Re: Catholic Archdiocese of Toronto Draft #3 Zoning Comments

We have reviewed Draft #3 and have the following comments.

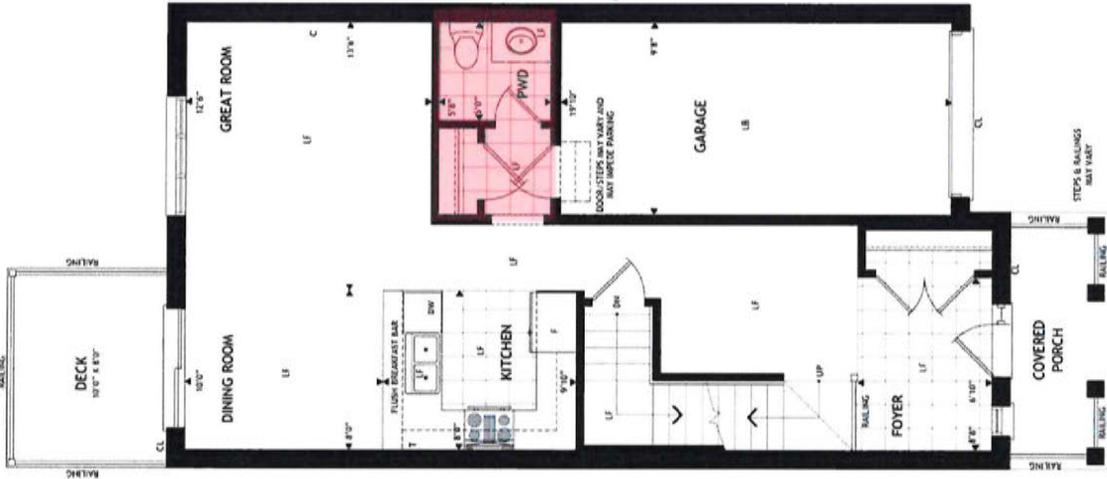
By extending the driveway and the building area required in the garage you are reducing the interior living space by 17%. This will have a major impact on design options especially for smaller square footage designs.

The impact is not limited to townhouse designs but also will be felt in smaller single-family dwellings, specifically on a 10.4-meter lot with single car garage designs. A typical single car garage averages around 18 square meters. An additional 4 square meters eliminates usable interior living space. Demonstrated in the floor plan below, is a 1700 square foot, single car garage design that would require the elimination of a main floor powder room, closet and garage entry to meet the

22sq meter minimum as prescribed in this bylaw. The marketability of such a design is impossible in a housing market currently driven by square footage and price.

Collector Roads – Lally Terrace, McAush, Prince William Way, Terry Fox Drive

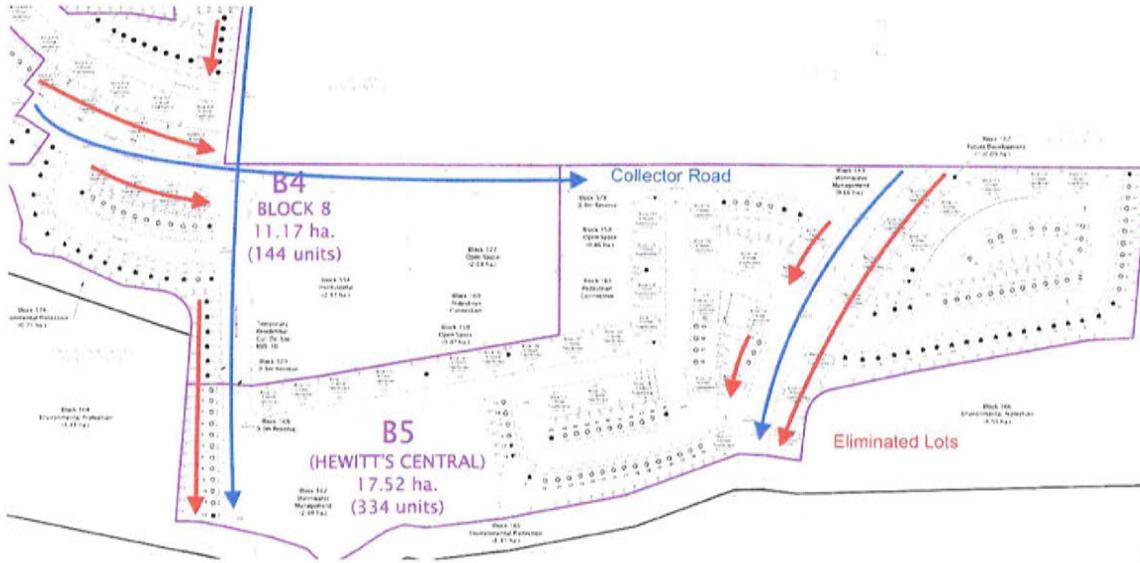
Note: Detached, Semi-Detached, and Rowhouse, On-Street and Back-to-Back buildings are only permitted when fronting onto Local Roads

ISSUE: This has significant density and cost implications for ground-oriented development. Every site designed in Hewitt's so far has had residential lots fronting collector roads.

The map below shows lots that would not exist under this rule. The current subdivision design for future Hewitt's has lots fronting on all 4 collector roads listed above and eliminating the ability for front facing lots will significantly reduce density and require a complete overhaul of the subdivision design. All of which will incur major engineering and design costs.

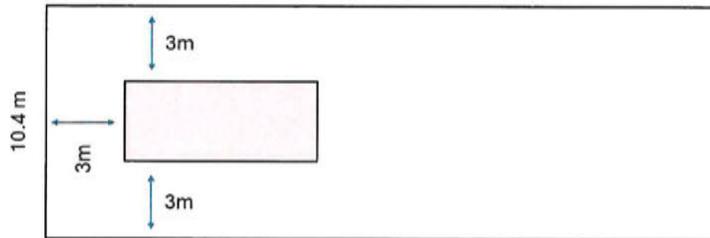
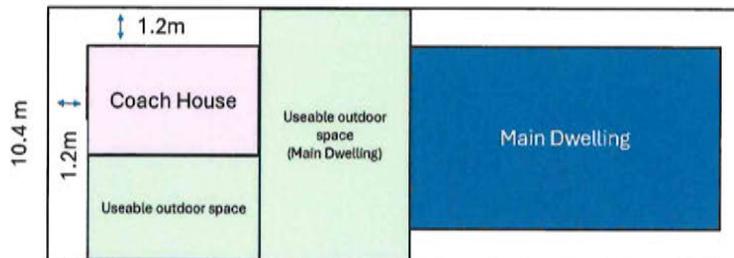
ISSUE: Current approved plans include lots specifically designed to include a Coach House. Picture below demonstrates the impact these setbacks will have on design and buildability on our already approved Site Plan.

The setbacks would eliminate most semi-detached and rowhouse lots given their minimum lot widths. Additionally, a standard 10.4m lot would allow for a maximum 4.4m wide coach house centered directly in the middle of the backyard. The design options with this restriction limit functionality and desirability of the dwelling. Further, this limits both dwelling units' access to a usable backyard area. By reducing the setback to 1.2m it allows for more design flexibility and more importantly, access to a usable outdoor space. See images below.

SOLUTION: Reduce setbacks to match Detached Garage rear and interior setback of 1.2m.
